**RE: Casey Fields South (Employment) and Devon Meadows Precinct Structure Plan (Amendment C295case)
1340 Ballarto Road, Cranbourne East (Property CF-01)**

Thank you for the opportunity to make a submission in relation to Amendment C295 to the Casey Planning Scheme and specifically the draft *Casey Fields South (Employment) & Devon Meadows Precinct Structure Plan (PSP)*, *Casey Fields South (Employment) & Devon Meadows PSP Drainage Strategy (Drainage Strategy)* and accompanying planning scheme provisions.

FIGURE 1: EXTRACT OF PLAN 11 – LAND USE BUDGET (CASEY FIELDS SOUTH (EMPLOYMENT) AND DEVON MEADOWS PSP, MARCH 2025)

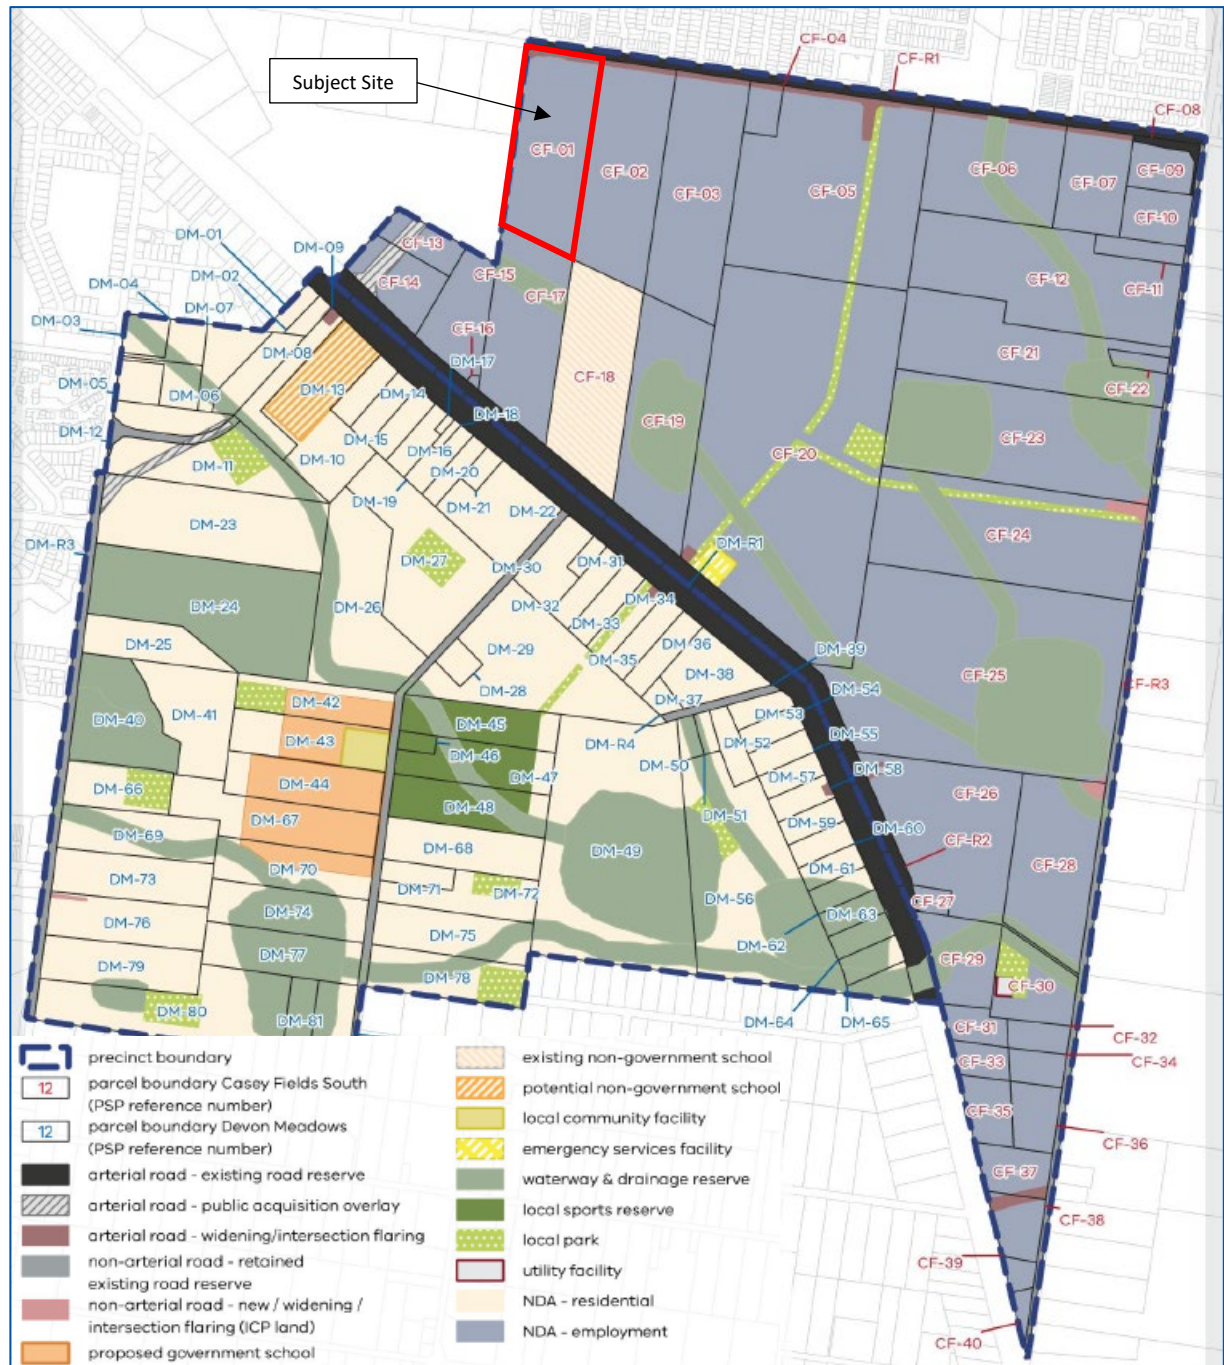
The Site is located at 1340 Ballarto Road in Cranbourne East and is located within the Casey Fields South (Employment) Precinct (**the Precinct**). The Site is identified as Property CF-01 within the PSP, as shown below. The Site is located on the south-east side of the future Ballarto Road and Casey Fields Boulevard intersection in the north-west corner of the Precinct. The Site is generally rectangular in shape and has a total area of approximately 8.34ha.
